SERVICE BULLETIN

224
No.

Piper Aircraft Corporation

SUBJECT: Mitchell Bulletin No. A55 — Modification of Pitch Servo

VIEW LOOKING DOWN THROUGH FLOORBOARD ON PILOT'S SIDE

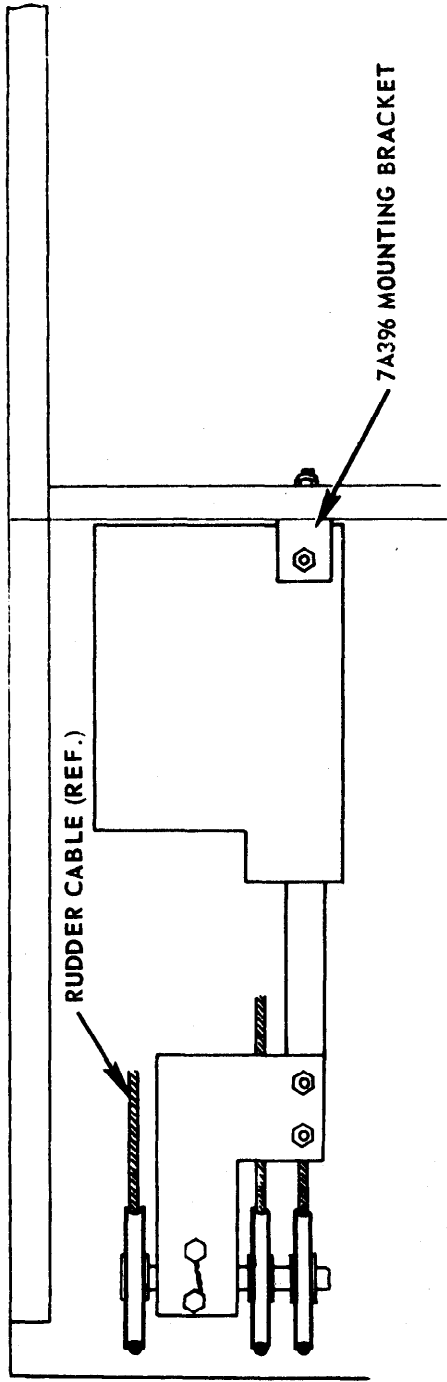
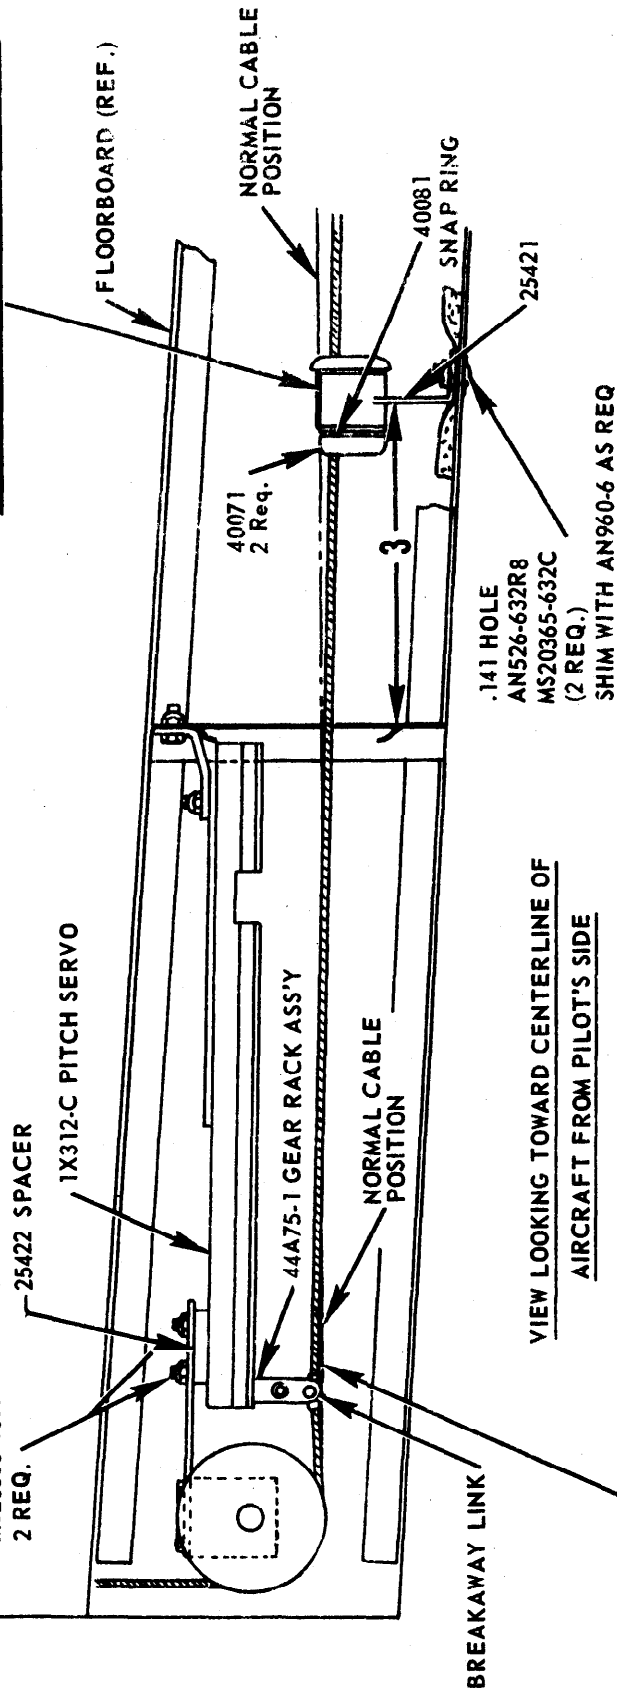
1. See Piper Electronic News Letter No. EL-48 for lubrication instructions
2. See attached sketch for details and installation of fairlead which is a part of this modification.

Install this bracket so the upper portion of the fairlead contacts the top of the cable. Use shim washers between skin and bracket to prevent cable deflection of more than 1/8 inch from its normal position.

Cable must have upward deflection of 1/16" thru full travel of rack assy.

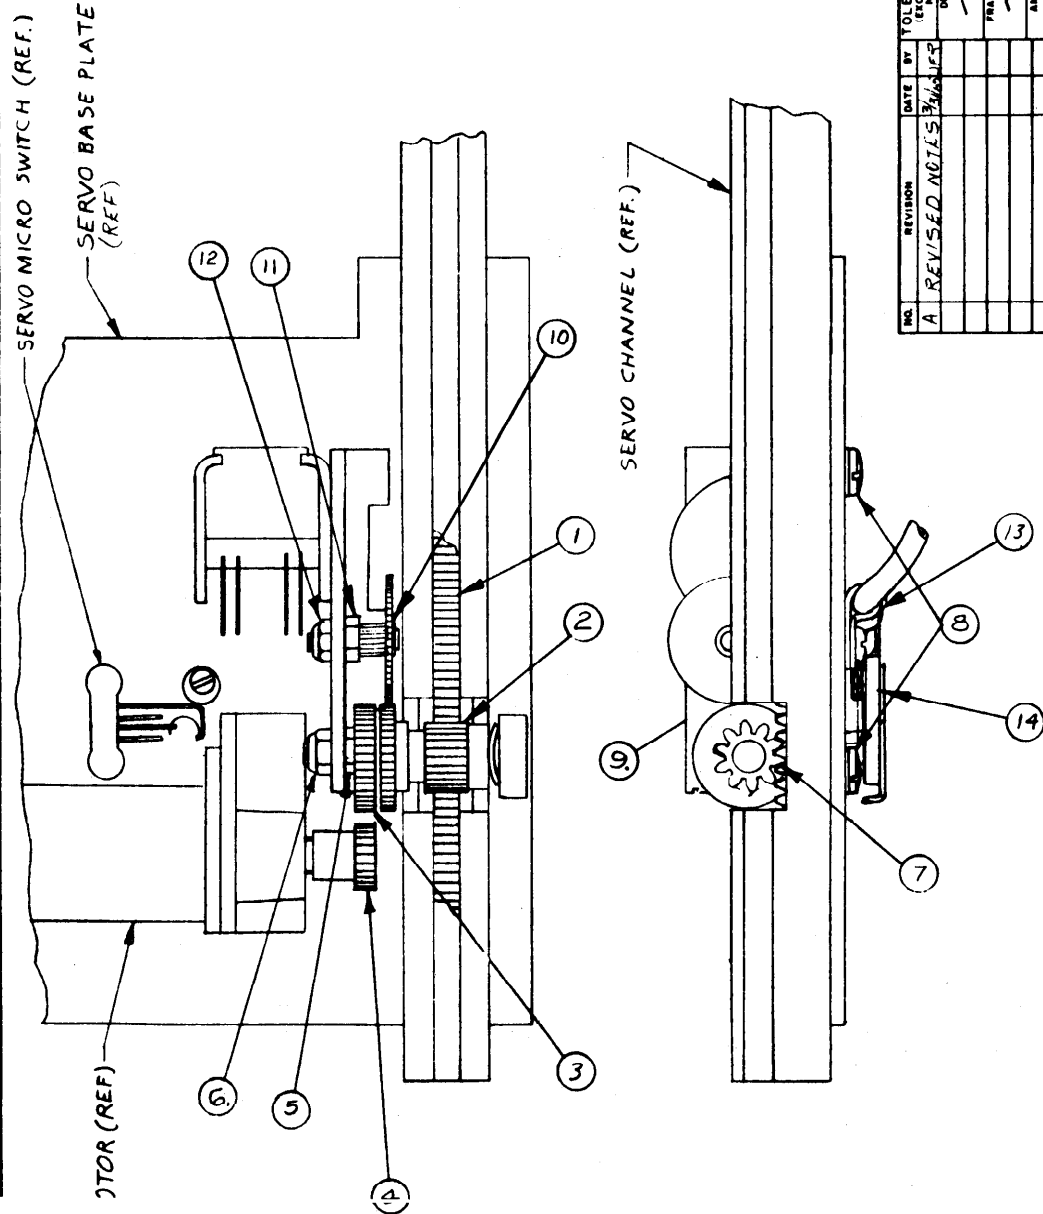
1. Disengage servo motor to obtain clearance between motor gear (4) and gear train (3).
2. Slide gear rack (1) into servo channel and under pinion (2). Move gear rack to both extremities in small increments to determine if gap (7) has minimum backlash and rack is free from binding.

3. If not properly adjusted, loosen gear train lock nut (6) and using a 1/2" open end wrench no thicker than 1/16", rotate gear train cam (5) until gear rack (1) will slide freely into position under pinion (2).

4. Idler gear (10) may have to be repositioned to obtain adequate clearance for adjustment of gear train (3). Loosen lock nut (12) and rotate cam (11) to obtain clearance.

5. Adjust cam (5) for minimum backlash between pinion (2) and gear rack (1) without binding.
6. Repeat step 2. to insure proper pinion adjustment.
7. Tighten lock nut (6) while holding cam (5) with 1/2 x 1/16 wrench.

8. Readjust idler gear (10) for minimum backlash without binding to gear train (3) by rotating cam (11), then tighten lock nut (12) securely.
9. Engage motor and observe mesh between motor gear (4) and gear train (3).

10. Servo motor micro switch should make contact before gears (4) and (3) start to mesh. If necessary, gear train support bracket (9) may be adjusted in either direction by loosening clamp screws (8).

11. Recheck all above points after screws and nuts are tightened.
12. After installation in aircraft, the servo lever (13) travel and engage control knob on console may be coordinated by slipping cable housing in the appropriate direction thru housing clamp (14).

DRAWING NO: 69D326
 INSTALLATION DRAWING
 FOR PITCH SERVO IN
 PIPER ALTIMATIC II
 MITCHELL INDUSTRIES INC.
 MUNICIPAL AIRPORT
 MINERAL WELLS, TEXAS

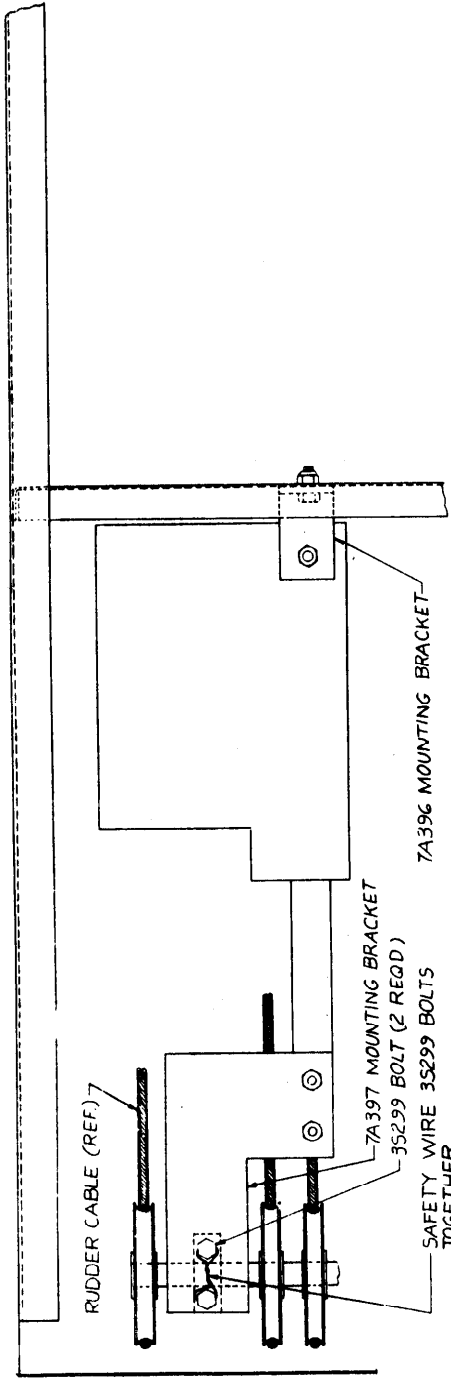
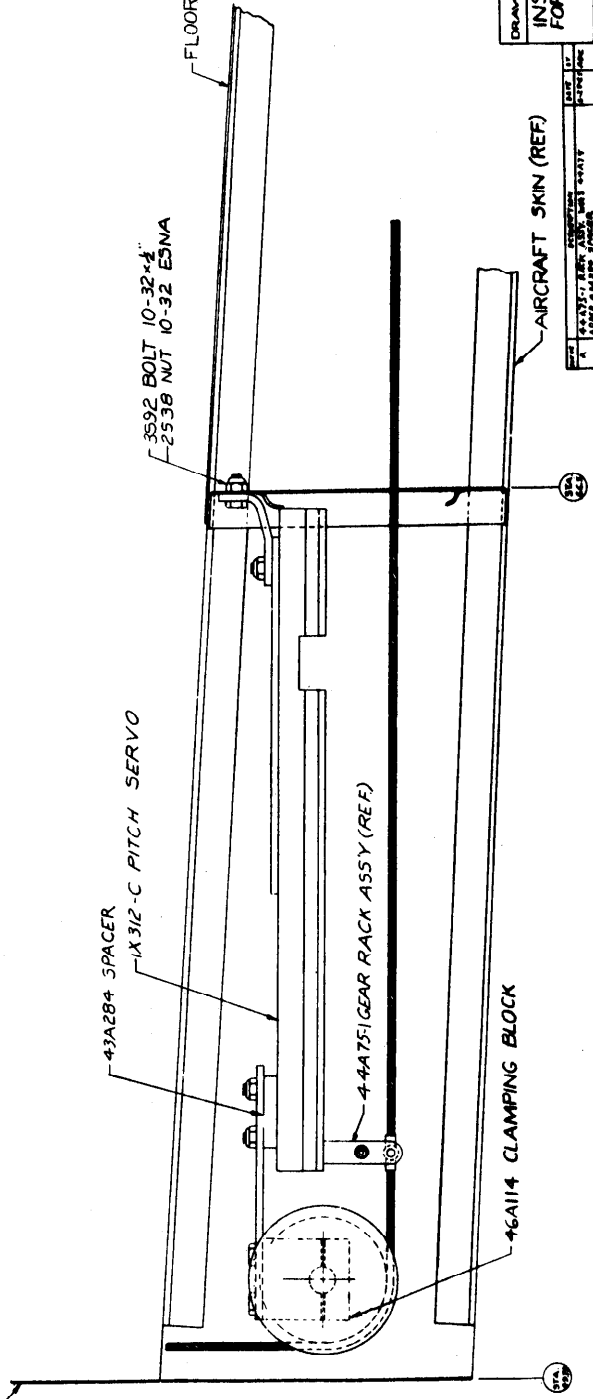
There have been several reports of interference occurring between the pitch servo rack assembly and the screw heads of the AN510-10R16 screws that attach the forward end of the servo to the forward mounting bracket. These screw heads should be inspected to be sure they are flush.

If the screws are not flush, then the pitch servo spacer block, part number 25422 should be removed and the two (2) holes increased to 1/4" diameter. Any subsequent installation should have the holes in the pitch servo block, part number 25422, drilled to 1/4" before it is installed.

PART NO. 44A75 1
 ISSUE: A
 CHANGES: 45A51 WAS ADDED
BA. ADDED SER, & NOTE 3. E0180RUF 3/23/64

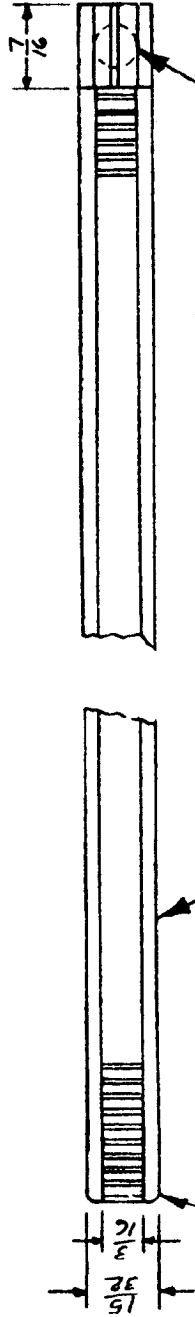
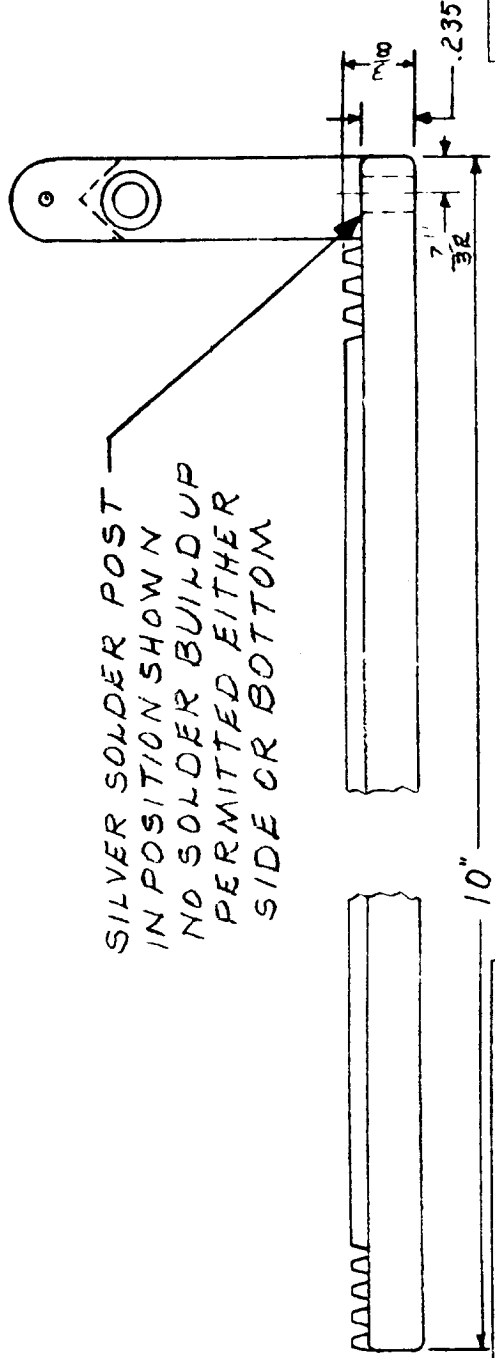
Inspection has revealed that the above pitch servo may have insufficient clearance for maximum safety between the rack post and stabilator cable after the "breakaway" ball is snapped out. To determine if this condition exists, remove scuff plate, carpet and inspection panel from floor below pilots rudder pedals. Snap cable ball free of servo and by moving control column full fore and aft, insure that ball does not catch or drag on servo post in any possible location along the post travel. If ball or cable tends to catch, replace servo rack gear and post assy. with P/N 44A75-1. (See attached Dwg)

- NOTE:
1. TEETH TO BE REMOVED $\frac{7}{16}$ " FOR POST MOUNTING.
 2. POLISH BOTTOM SURFACE BEFORE AND AFTER PLATING.
 3. PART TO BE FREE OF ALL BURRS.

SILVER SOLDER POST IN POSITION SHOWN
 NO SOLDER BUILDUP PERMITTED EITHER SIDE OR BOTTOM
